Special features of Hamilton By-Pass Motorway (M74)

J. PATON, D. D. FRASER & J. B. DAVIDSON

Fig. 15. Relationship of the percentage of traffic turning to the number of weaving, merging and diverging decisions

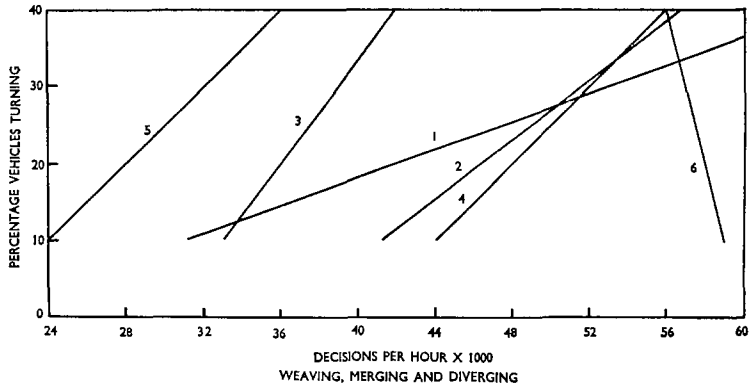
131. Fig. 15 shows the relationship of the percentage of traffic turning to the number of weaving, merging and diverging decisions required per hour assuming a feed of 3000 vehicles each way on the major route and 2000 vehicles each way on the minor route. Fig. 16 shows the six alternative solutions which were considered for this analysis.

133. In this type of analysis it will be seen that for higher turning volumes the two and three level roundabout systems and the clover leaf fare rather badly, and the

single level roundabout, although it improves with higher turning volumes, may be discounted for other reasons.

134. Since all these types have either been adopted or considered and rejected during the design studies, especially in connexion with the A723 interchange, I should be most interested to know whether the Authors believe that this type of analysis should be a contributory factor in the selection of interchange solutions.

Mr Twigg's comment concerning the volume of turning vehicles at the two- and three-level roundabout and clover-leaf forms of interchanges is interesting.

149. The question of vehicle conflict and driver decision should be a factor in the final choice of interchange layout. It was certainly a factor in our designs. It can only be one factor, among many, because to achieve a high degree of satisfaction in this respect involves extra cost and, as in all civil engineering problems, cost at the end of the day tends to determine the layout to a considerable extent.

Fig. 16. Six alternative solutions

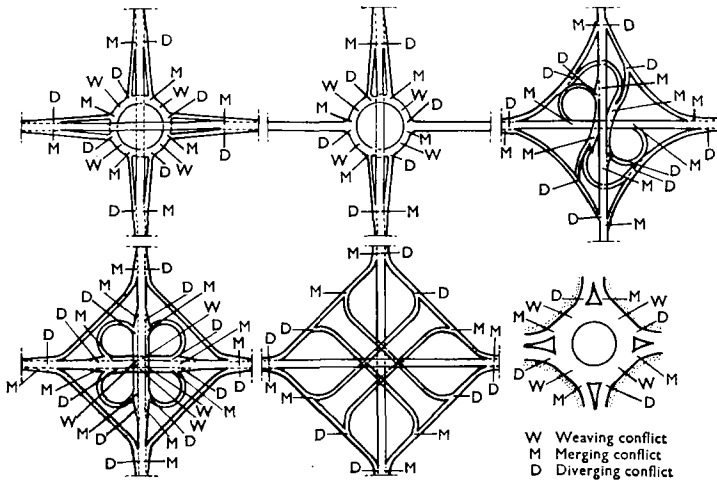
132. These six alternative solutions for a hypothetical problem have been prepared assuming equal turning proportions from each of the four feeder roads. Although this percentage in practice will, of course, vary according to the requirements of the traffic predictions, the principle of the analysis will remain unaffected.
